10/694,463

Office Action Summary

DENICOLA

FIG. 1

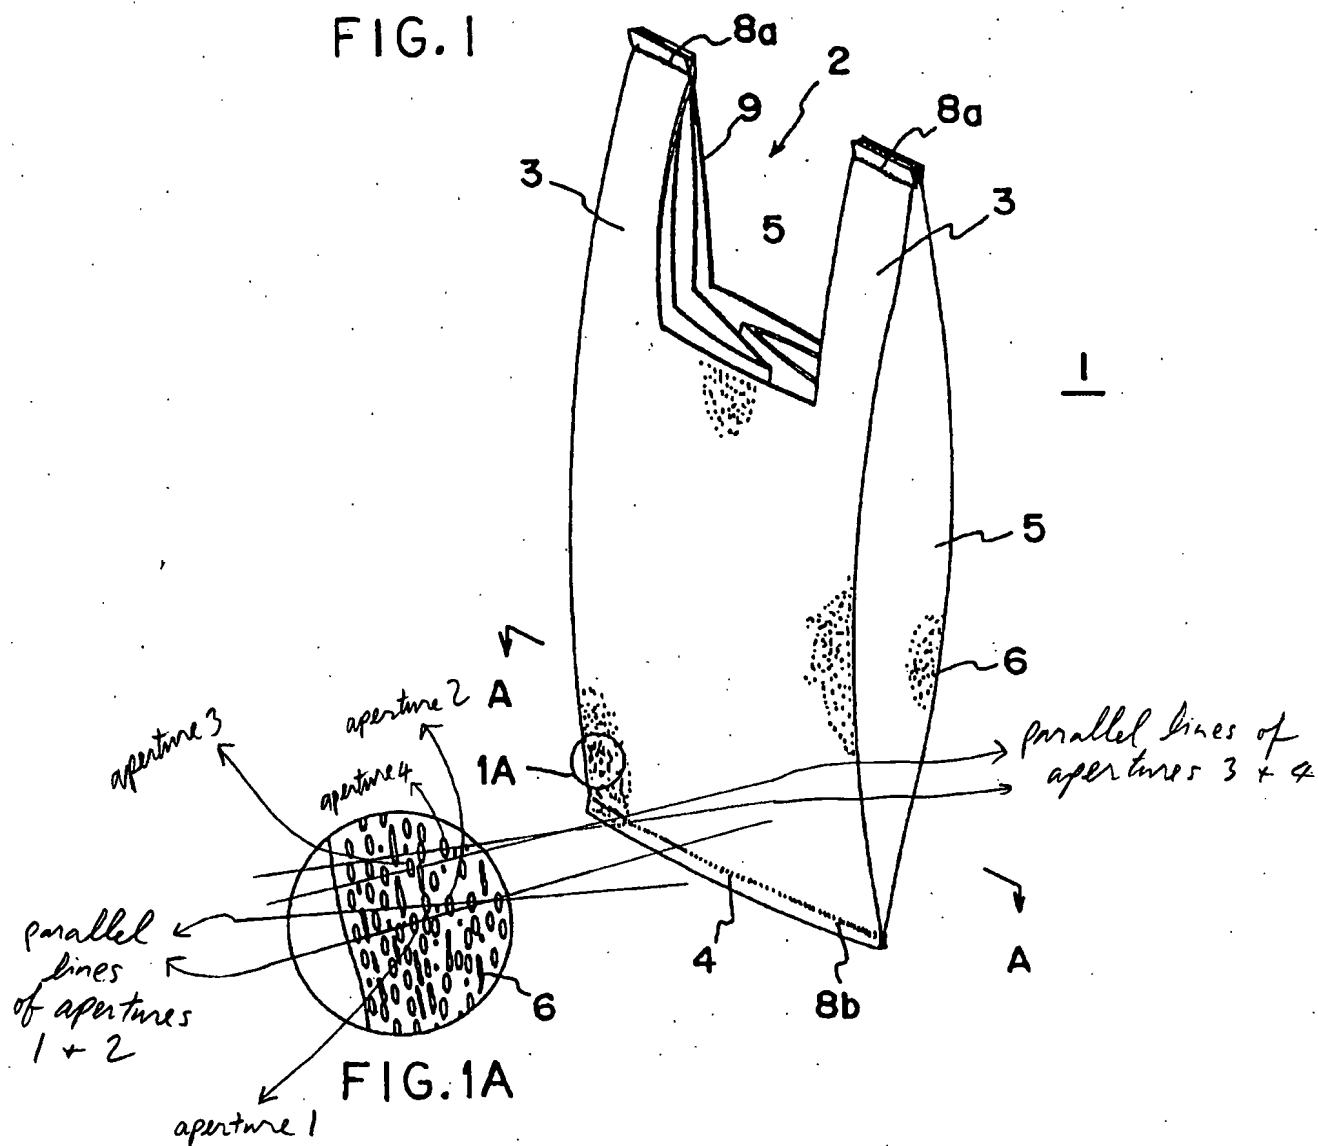
16. Applicant further argues that Takita does not disclose antiparallel orientation of the apertures, Applicant's argument is acknowledged. However, it is noted that Figure 1A (attached at the end of this office action) shows the antiparallel orientation (note that

the parallel lines of the apertures are crossed and therefore, it is anti-parallel oriented) of the apertures.
